**Office Action Summary**

09/768,912

KAWAI, HIROJI

**FIG. 7E**

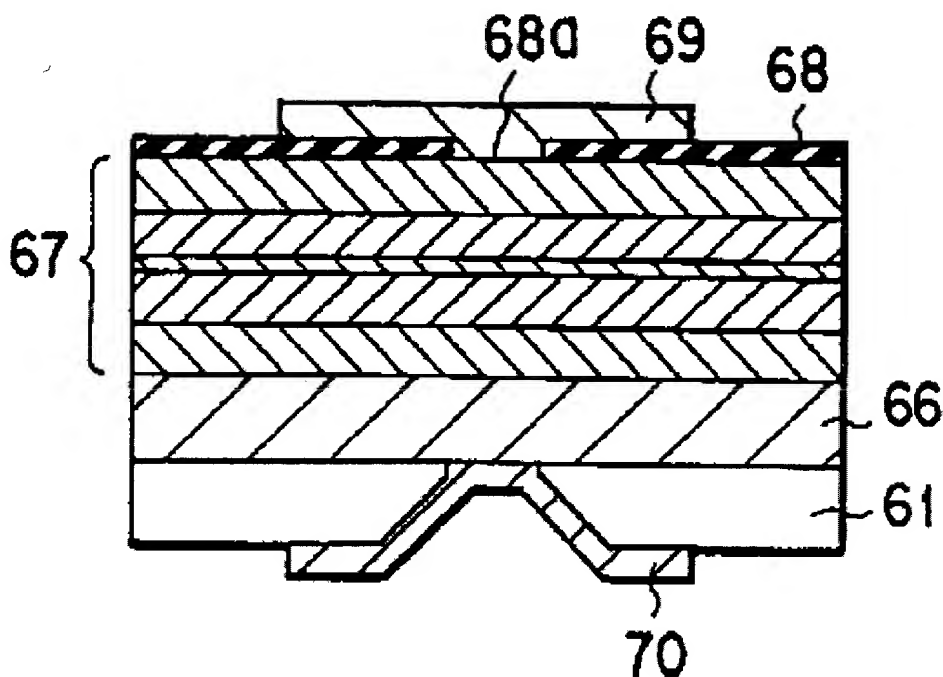
Claims 9-12 are rejected under 35 U.S.C. 102(b) as being anticipated by Nunoue (US 5,905,275). Nunoue discloses the limitations of claims 9-11, namely a semiconductor device where a single crystal sapphire substrate 61 has a GaN semiconductor laser 66-69 formed on a major surface. An electrical connection to the device is made through an electrode 70 in a hole formed on the substrate (Fig. 7e, col. 8 line 14 - col. 9 line 58).
